VILLAGE OF ROYAL PALM BEACH, FLORIDA

PROJECT NAME: COMMONS PARK PATHWAY LIGHTING  
PROJECT NUMBER: PR1903

**ADDENDUM NUMBER: FIVE**

DATE OF ISSUANCE: September 28, 2021

**NEW SERVICE POINT 'W1' RISER DIAGRAM**  
120/240V, 1PHASE, 3 WIRE

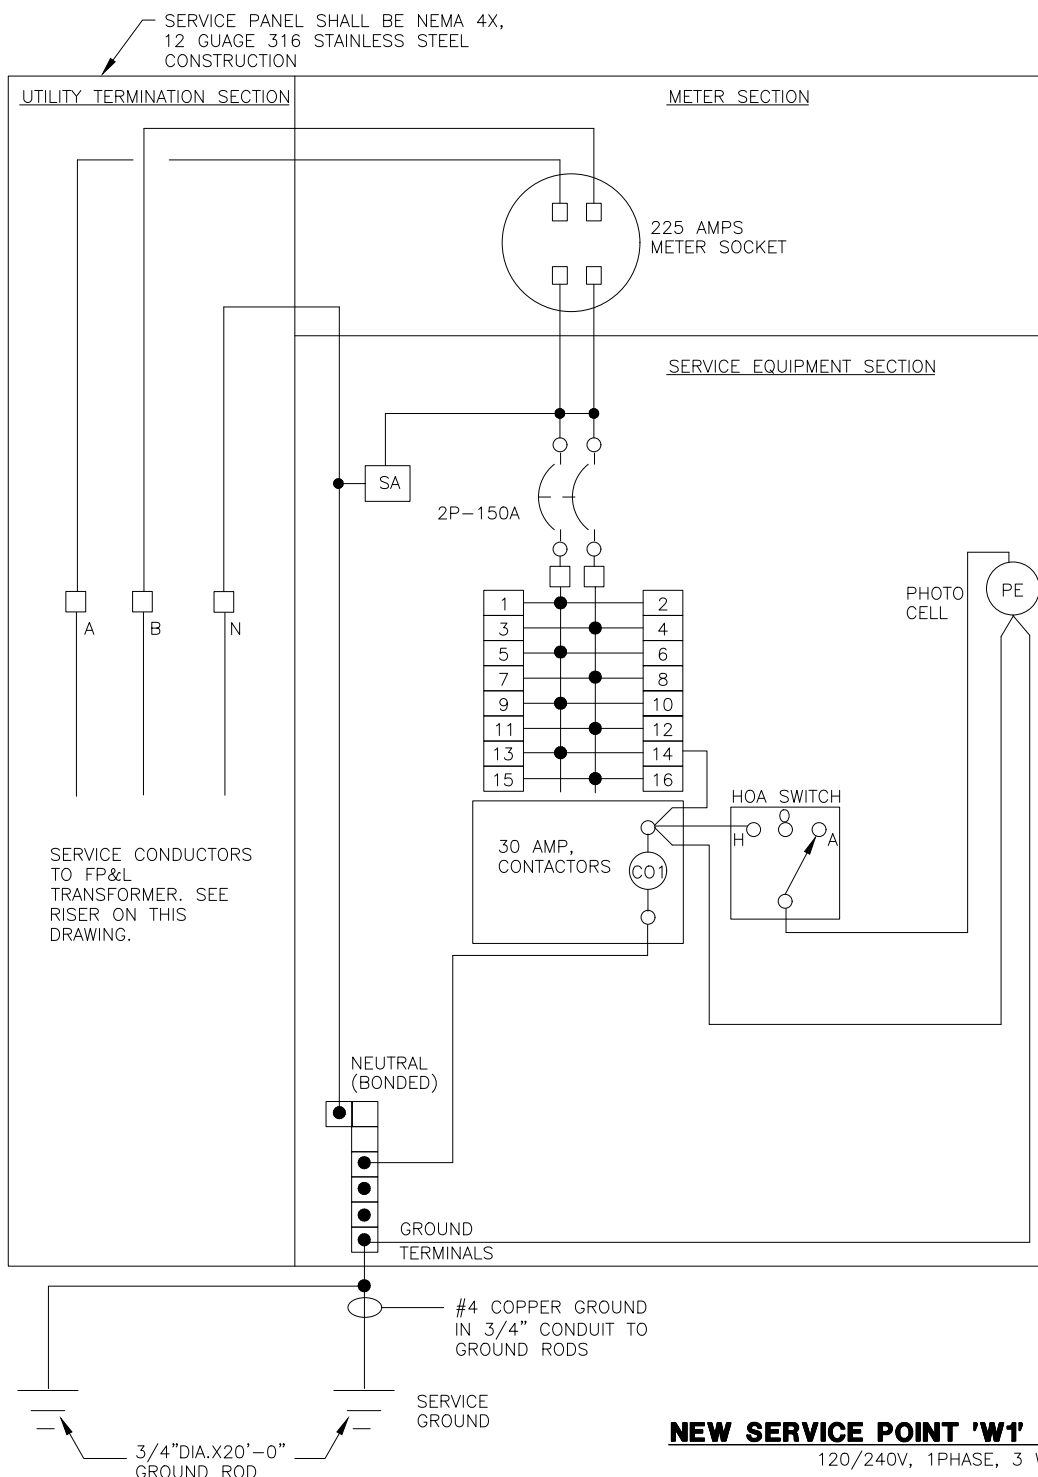
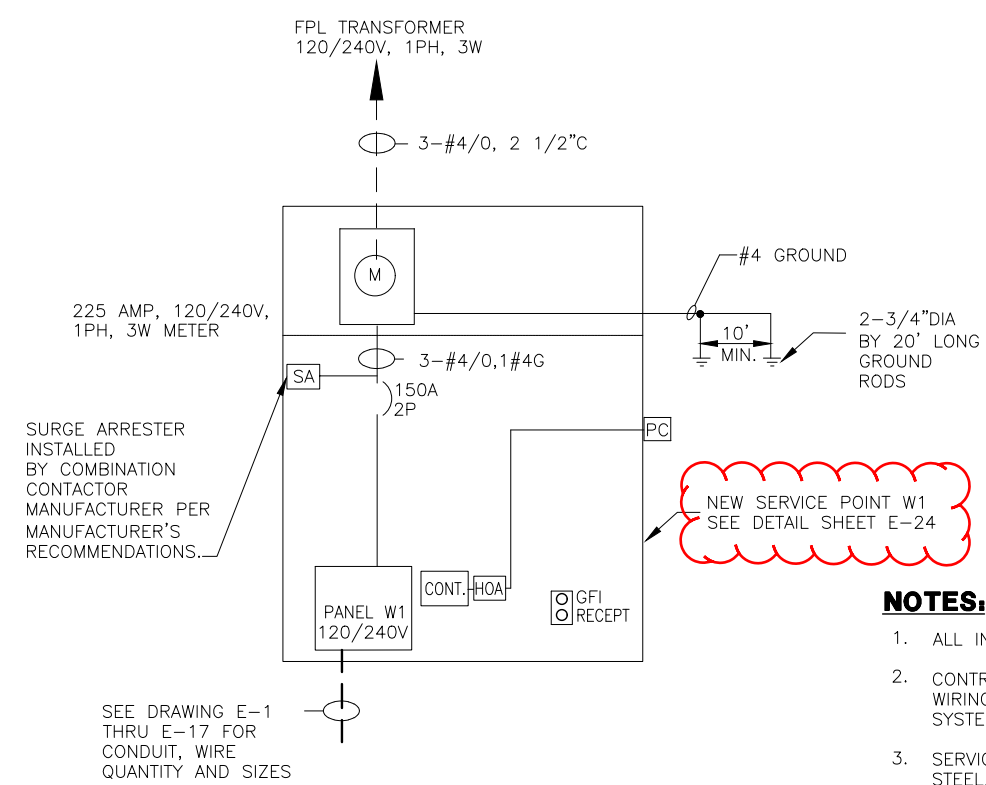
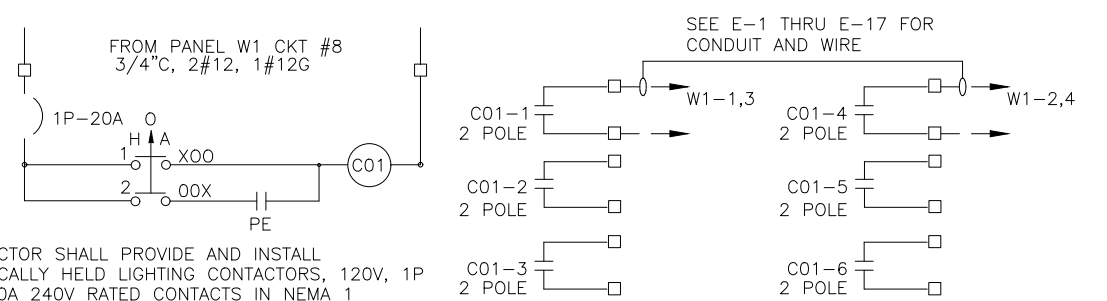
Addendum 5 Revisions:  
Referenced sheet number has been corrected.

**NEW SERVICE POINT 'W2' RISER DIAGRAM**  
120/240V, 1PHASE, 3 WIRE

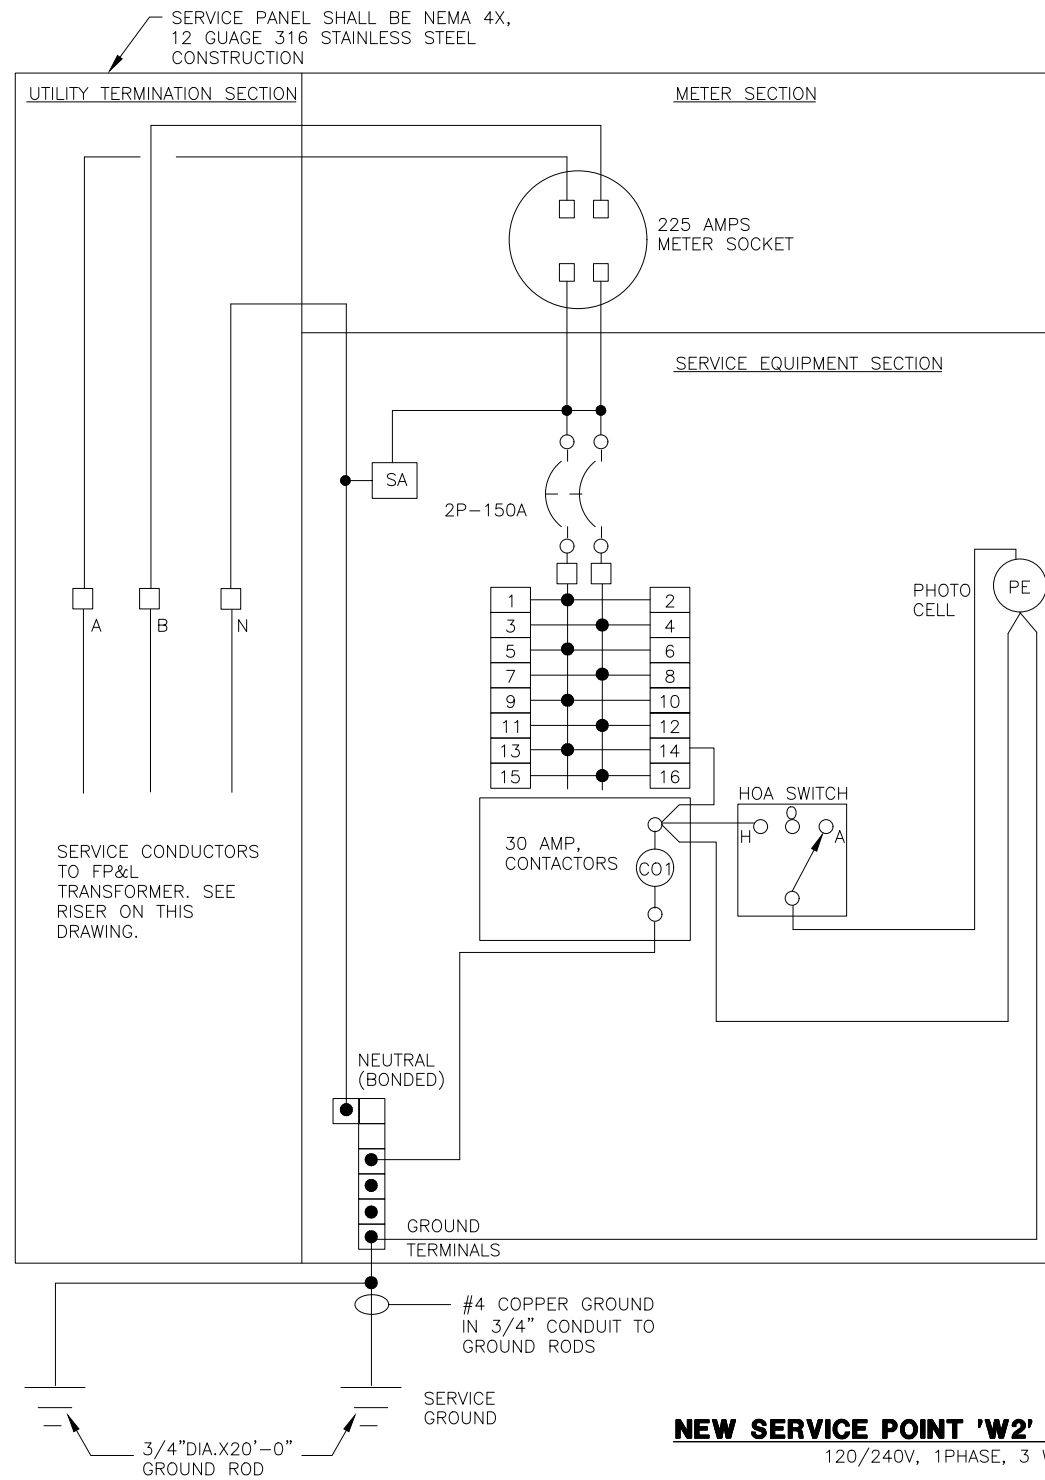
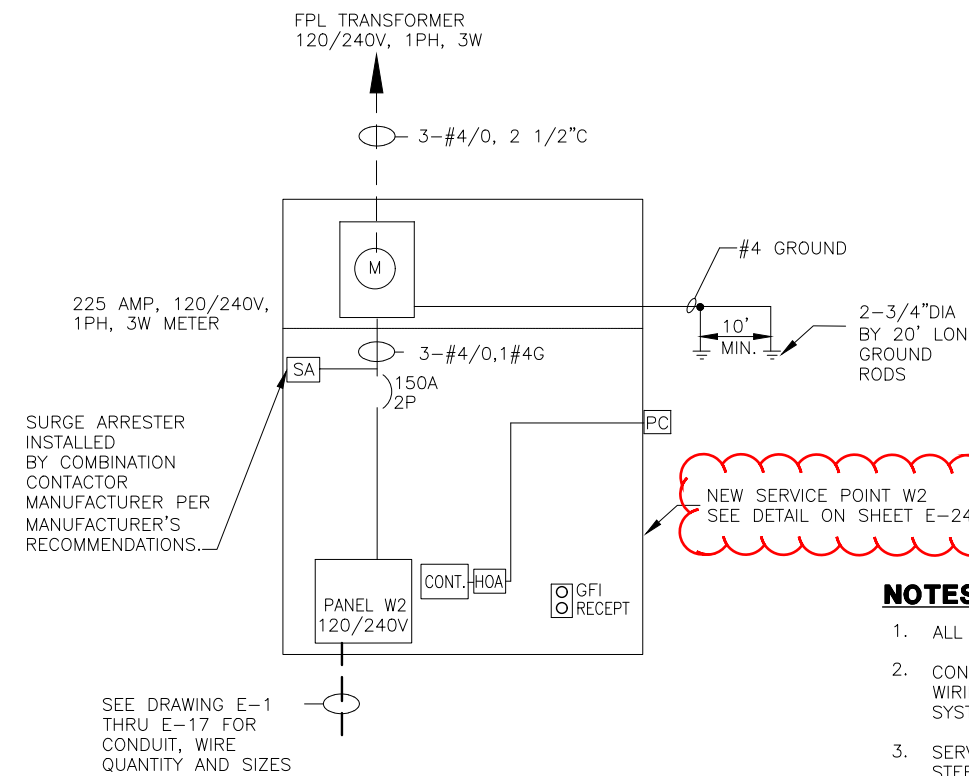
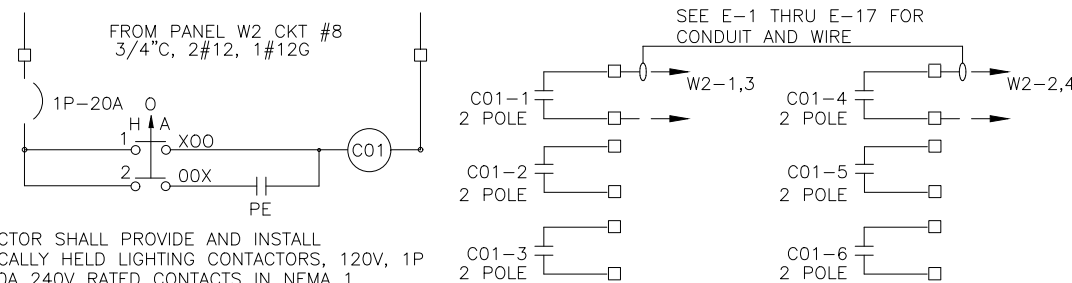
Addendum 5 Revisions:  
Referenced sheet number has been corrected.

**NEW SERVICE POINT 'W3' RISER DIAGRAM**  
120/240V, 1PHASE, 3 WIRE

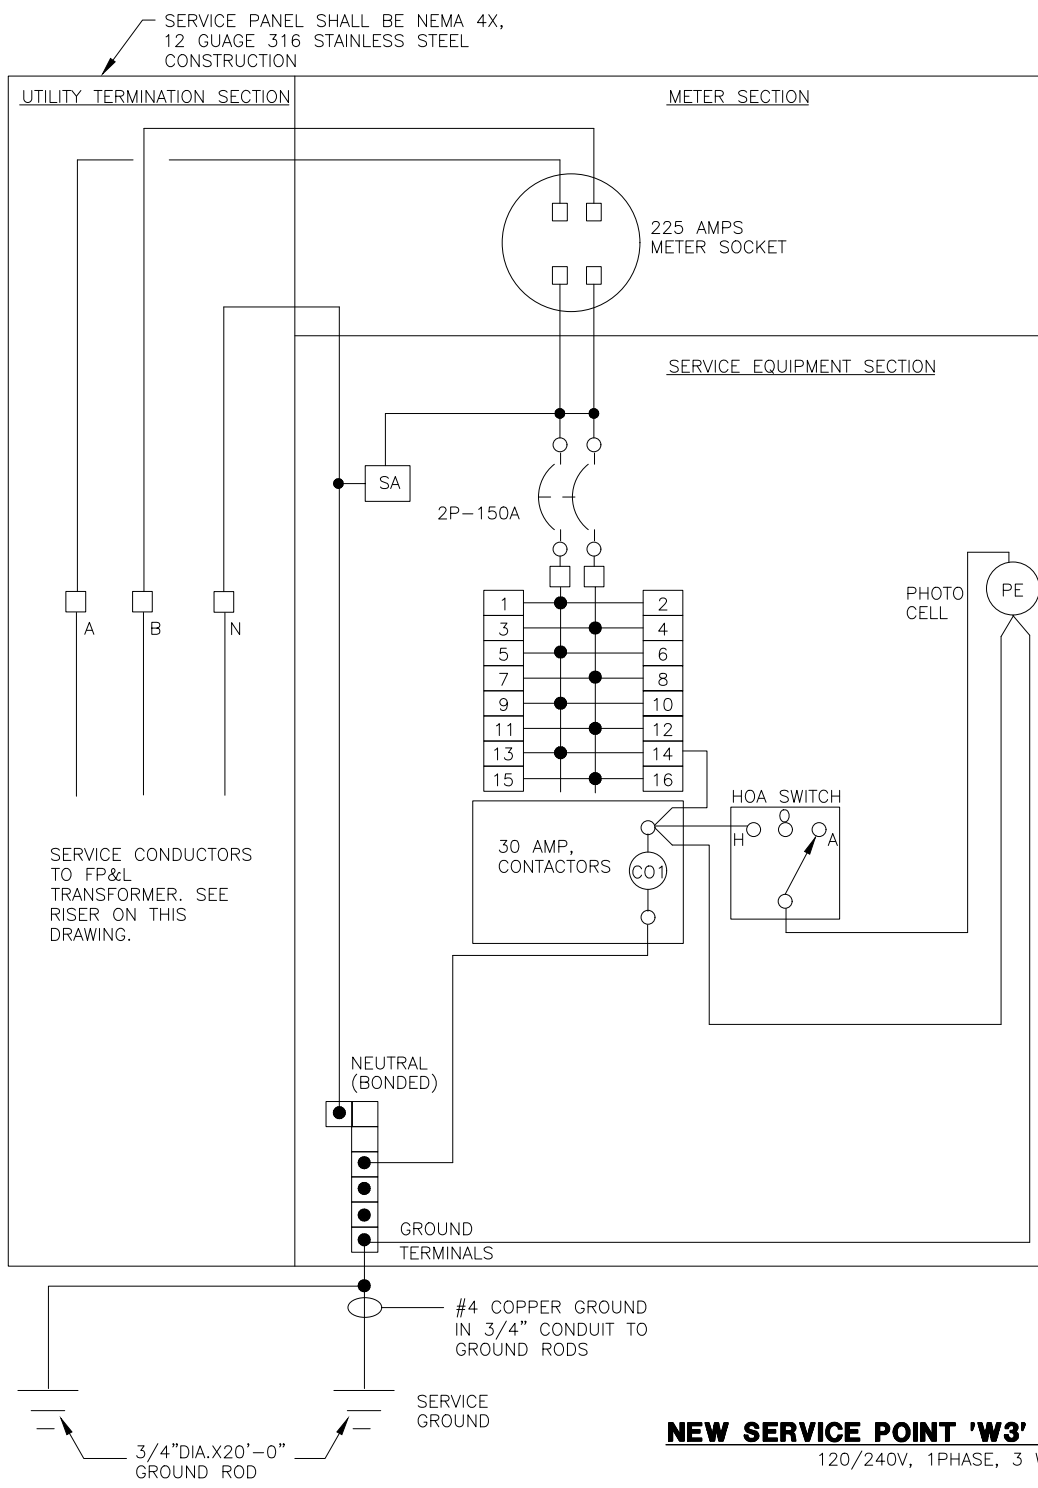
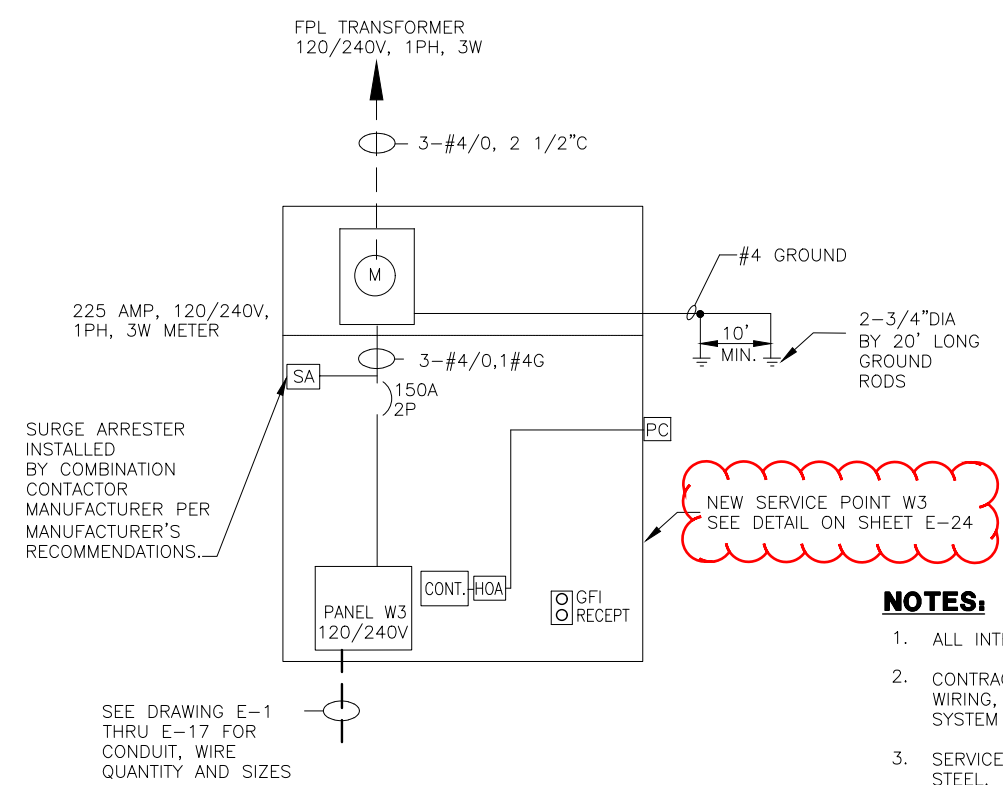
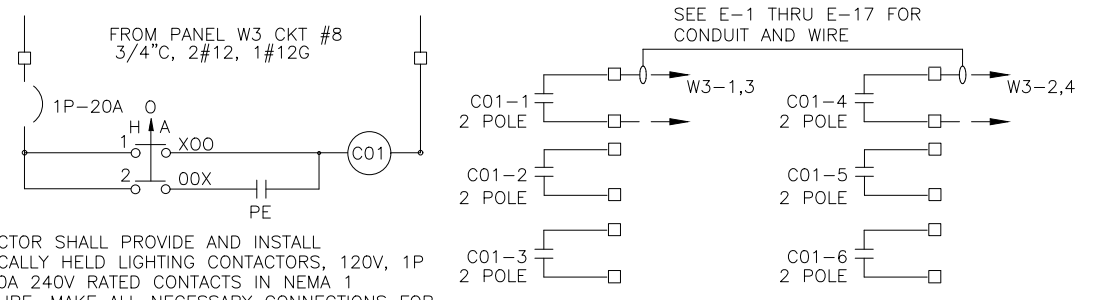
Addendum 5 Revisions:  
Referenced sheet number has been corrected.
